Work Order ID 162650

Item Name: AS350/AS355 Quick Release Heli-Utility-Basket™ Long, Heavy Duty Lid

DART SERVICE INSTRUCTION

TO AMEND INSTALLATION INSTRUCTIONS D350-607-3 Rev.D,
INSTALLATION INSTRUCTIONS D350-607-4 Rev. C AND
INSTRUCTIONS FOR CONTINUED AIRWORTHINESS ICA-D350-607 REV. 6

FIGURE 1: INSTALLATION OF D4775-041 FWD STRUT

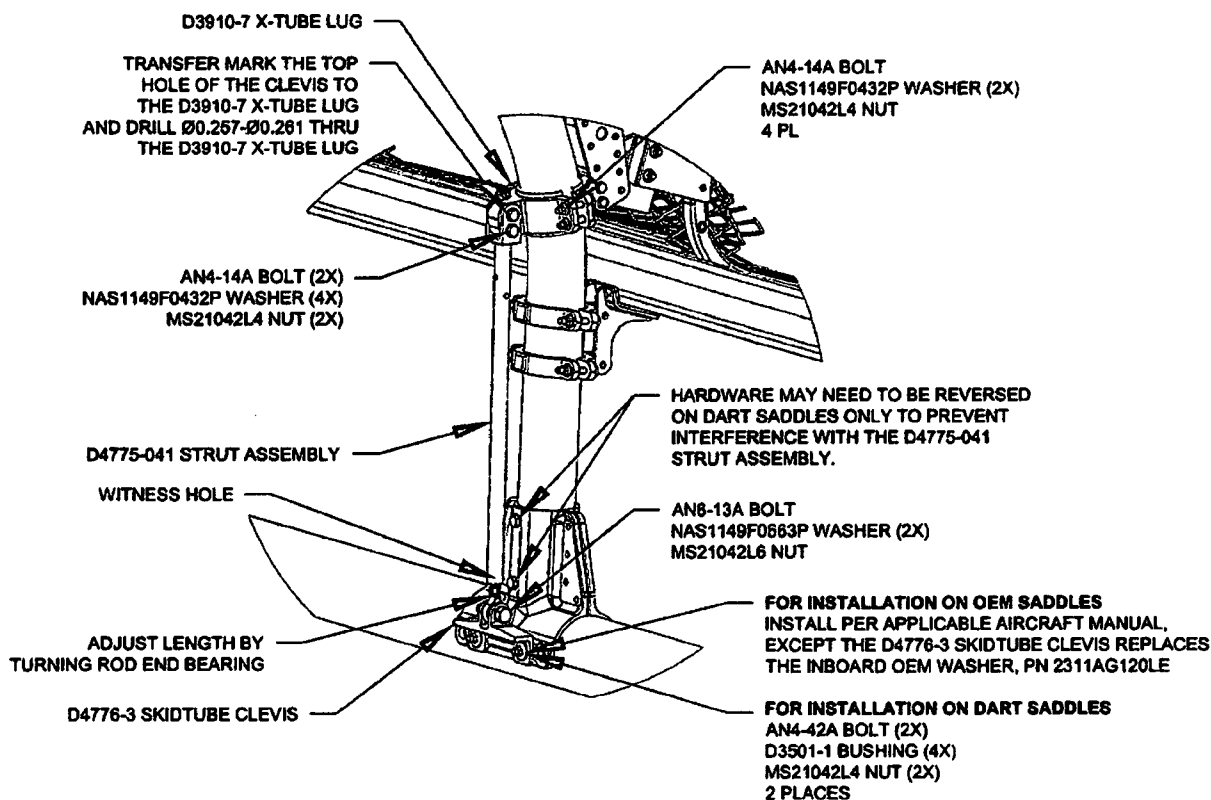
3.1 Substitute the Forward Lower D3910-5 X-Tube Lug with the D3910-7 X-Tube Lug as shown in Figure 1.

3.2 Install the forward D4775-041 Strut Assembly. Transfer mark from the upper hole on the clevis of the D4775-041 Strut Assembly to the D3910-7 X-Tube Lug and drill thru the lug $\varnothing 0.257$ - $\varnothing 0.261$ as shown in Figure 1. Touch up chemical conversion coating per MIL-DTL-5541. Check the witness holes located at the bottom end of the D4775-041 Strut Assemblies to ensure that the thread from the rod end extends past the witness hole.
Torque MS21042L4/-4 nuts to 50-70 in-lbs (5.7-7.9 N-m). Torque MS21042L6/-6 nuts to 160-190 in-lbs (18.1-21.5 N-m).
